Subject: WA/12/18/PL Shell Fontwell

Your Ref
WA/12/18/PL
Our Ref
PLAN-021992
Date
21/03/2018

Proposal: Replacement sales building, canopy link removed, new bin store, delivery bay, front of store customer parking, replacement of condensers & 2 No new electric charging points.
Site: Shell Filling Station, Arundel Road, Fontwell, BN18 0SB.
WA/12/18/PL

Southern Water MapGuide Browser

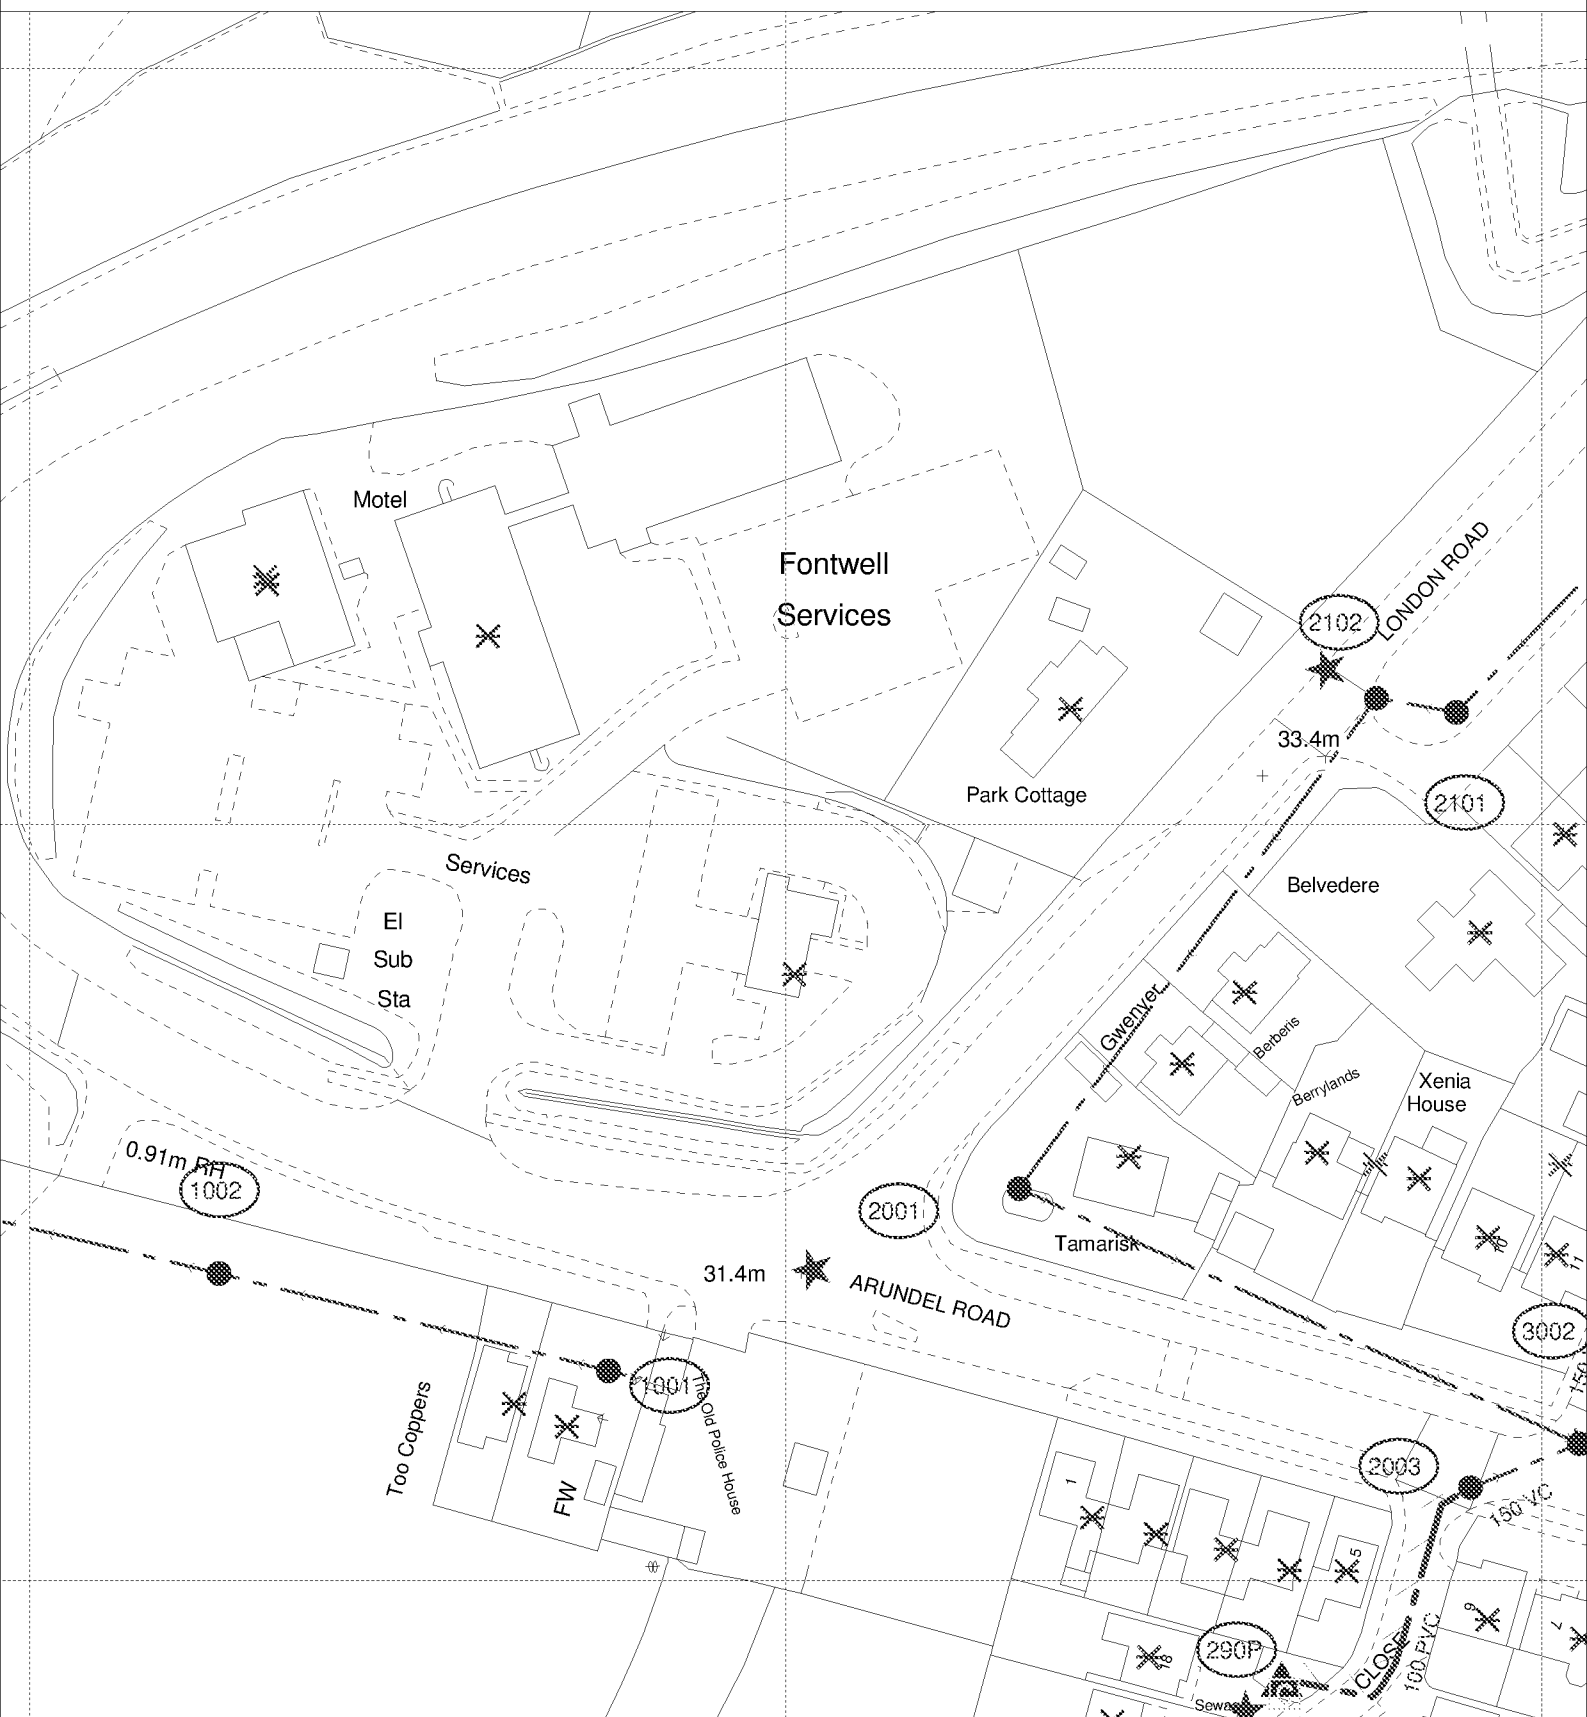
Southern Water requires a formal application for a connection to the foul sewer to be made by the applicant or developer.

Our initial investigations indicate that there are no public surface water sewers in the area to serve this development. Alternative means of draining surface water from this development are required. This should not involve disposal to a public foul sewer.

The Council's Building Control officers or technical staff should be asked to comment on the adequacy of soakaways to dispose of surface water from the proposed development.

Due to changes in legislation that came in to force on 1st October 2011 regarding the future ownership of sewers it is possible that a sewer now deemed to be public could be crossing the above property. Therefore, should any sewer be found during construction works, an investigation of the sewer will be required to ascertain its condition, the number of properties served, and potential means of access before any further works commence on site.

The proposed development would lie within a Source Protection Zone around one of water supply sources as defined under the Environment Agency's Groundwater Protection Policy. Consultations with the Environment Agency to ensure the protection of the public water supply source.
